Applicants : Philip J. Quenzi and Richard W. Jenney
Serial No. : 10/796,619
Page : 4

Remarks:

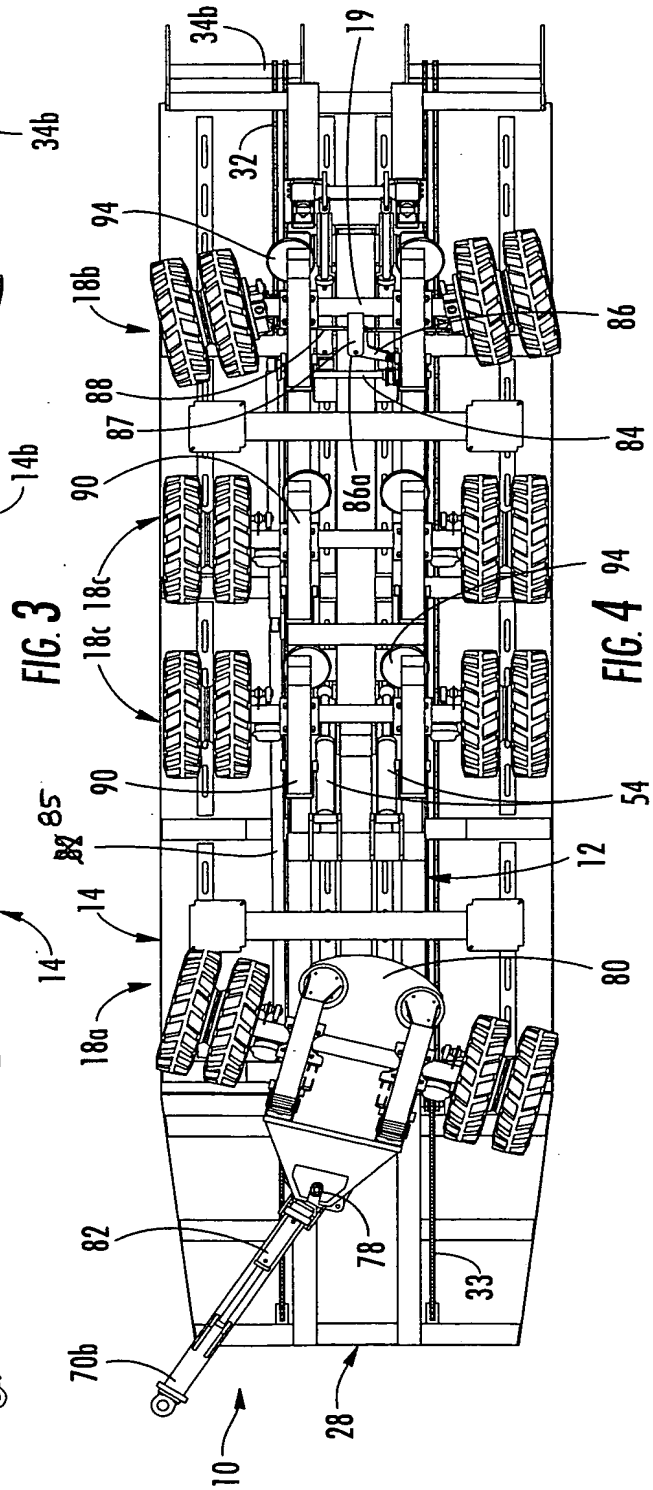
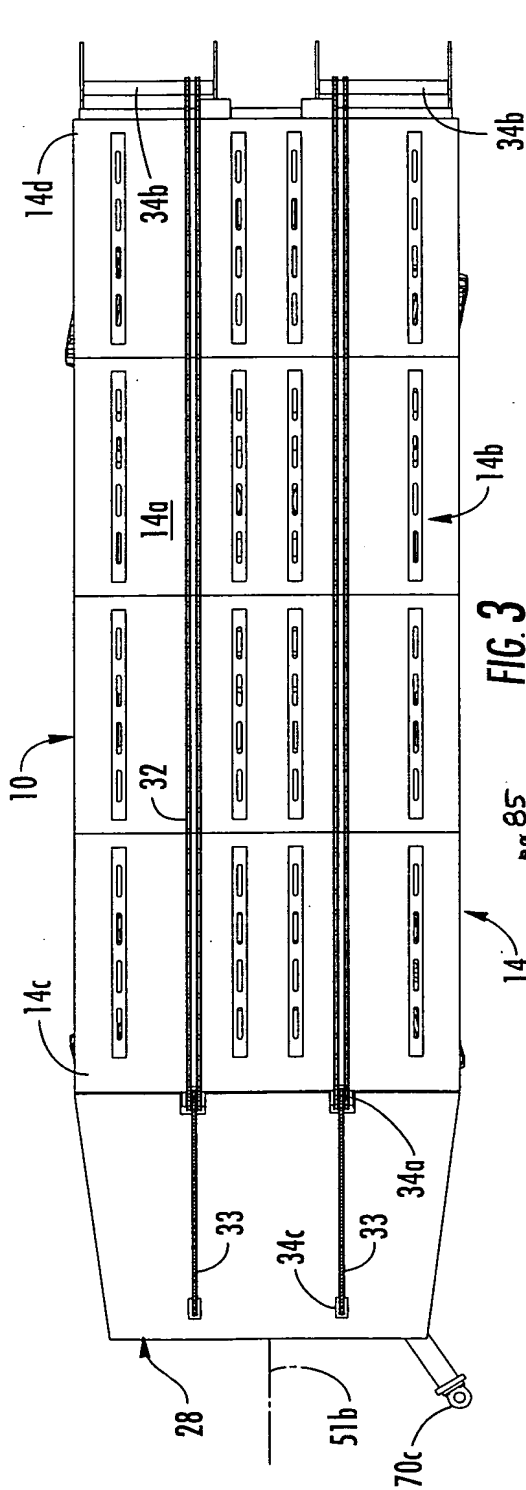
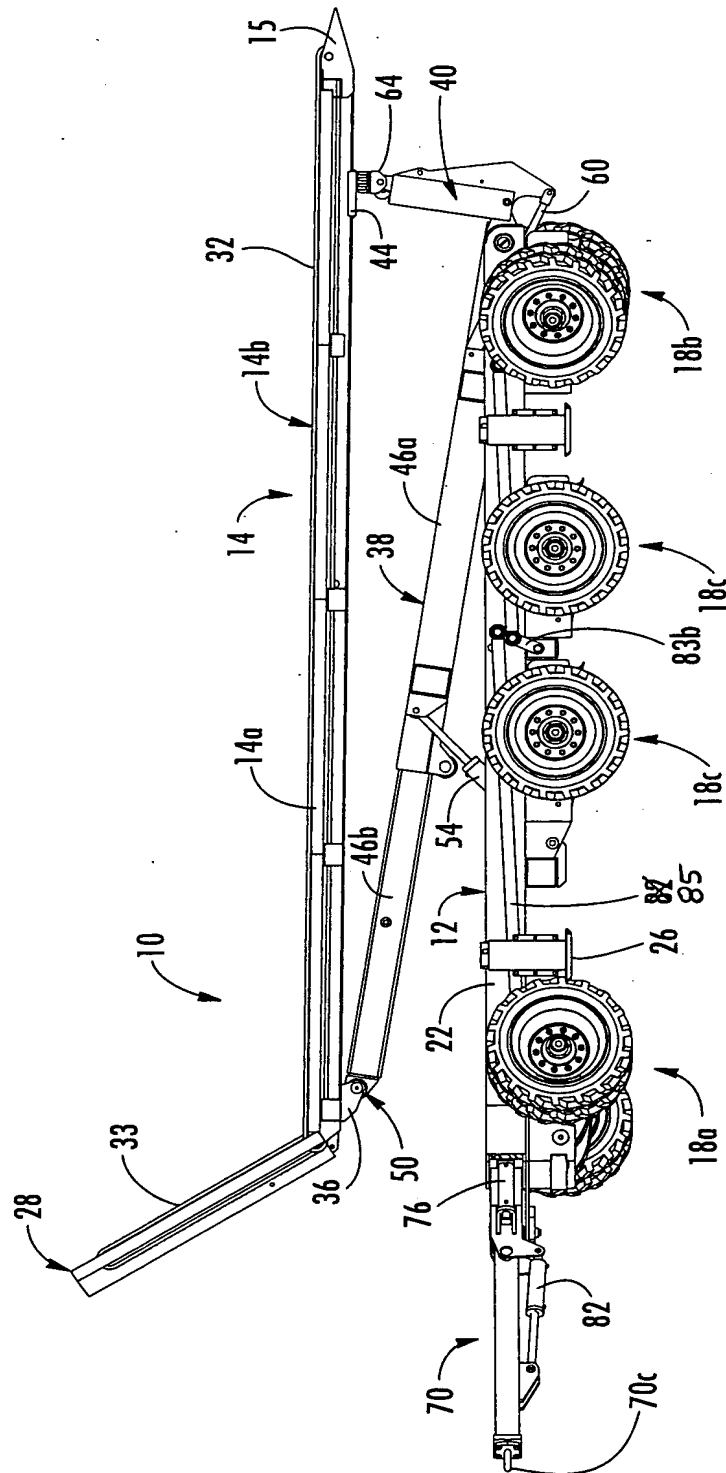
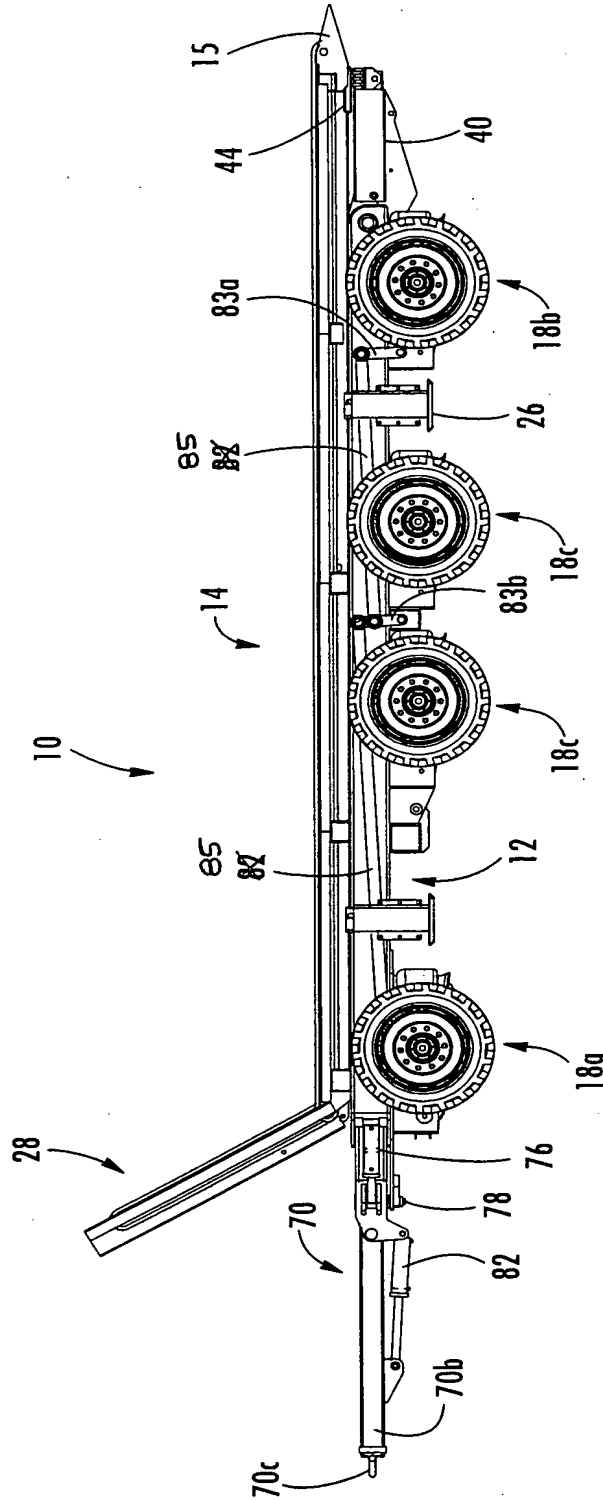
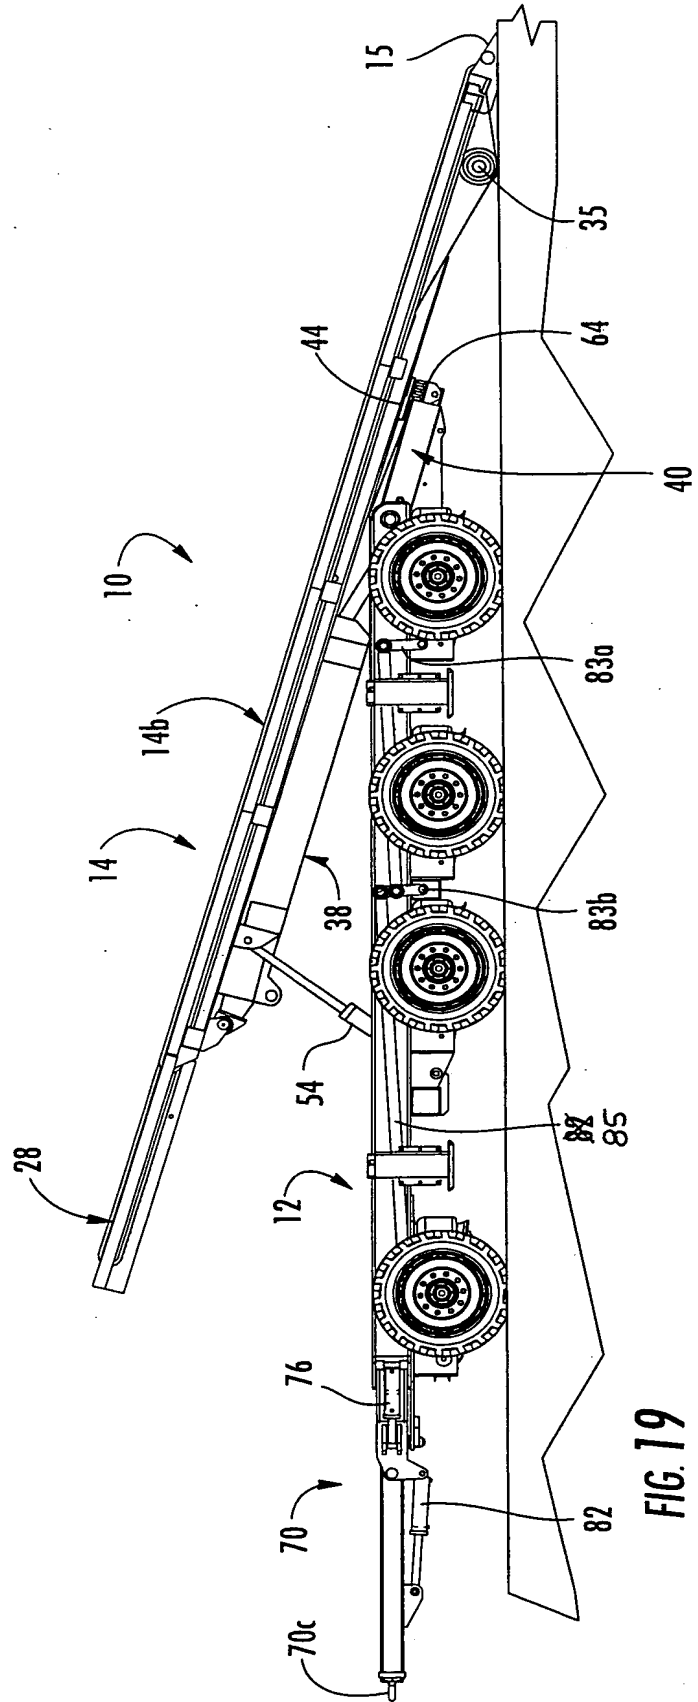
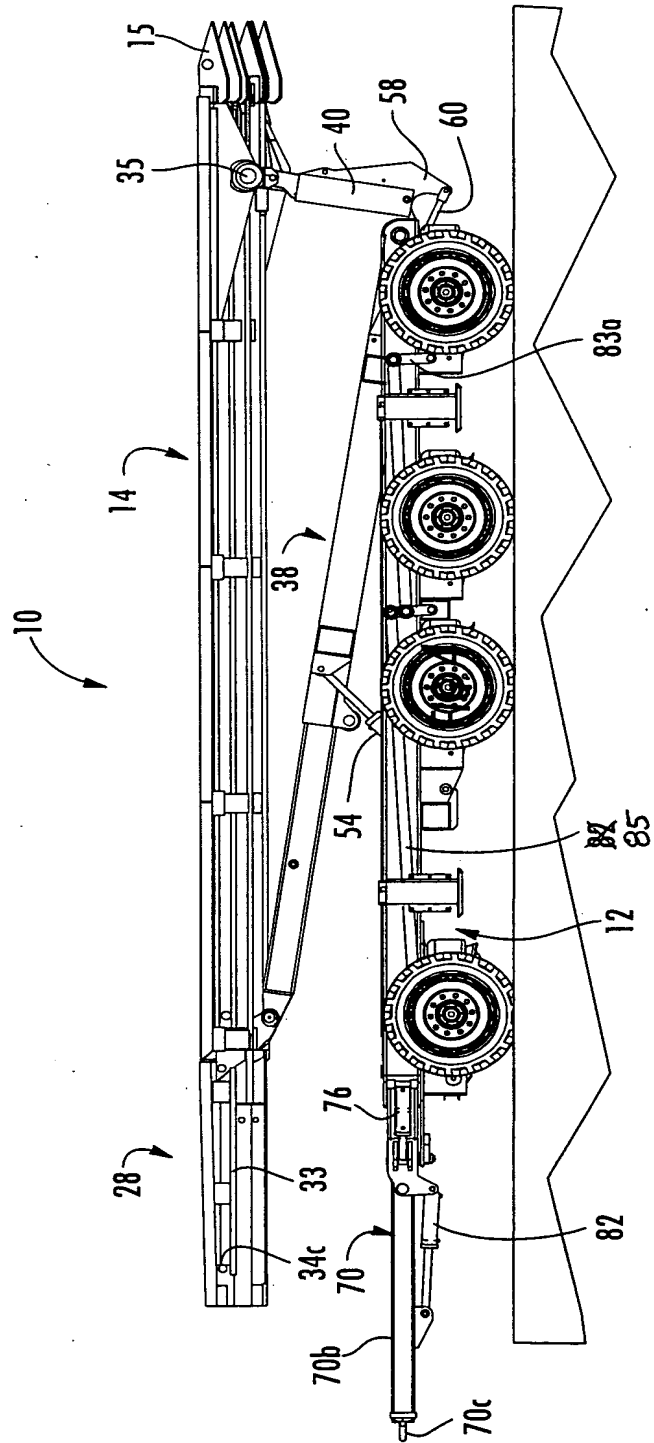
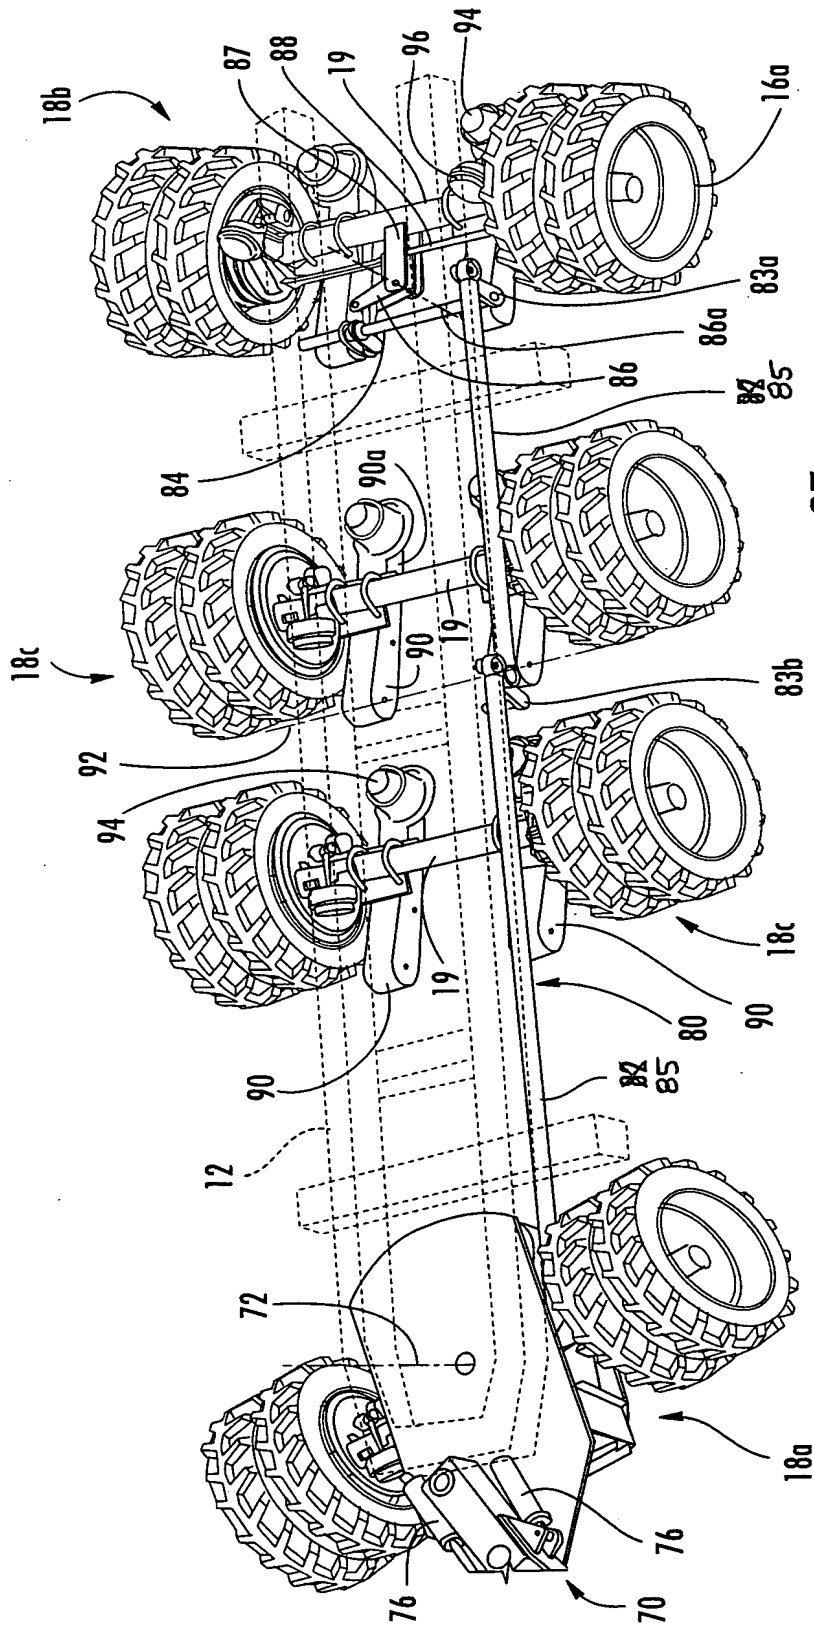
Upon review of the formal drawings for this application, it was discovered that the reference number 82 was used to refer to the actuator and to the linkage or connecting member. The specification has been amended to change the reference number 82 for the linkage to reference number 85, in order to correct this error. The drawings have also been amended accordingly. Attached are new formal drawings for this application, with this change made in Figures 1, 4, 8, 9, 19, 22 and 27. Also attached are marked up versions of Figures 1, 4, 8, 9, 19, 22 and 27, showing the change to the reference numbers. The drawing and specification amendments are fully supported in the specification and drawings as originally filed. No new matter has been added.
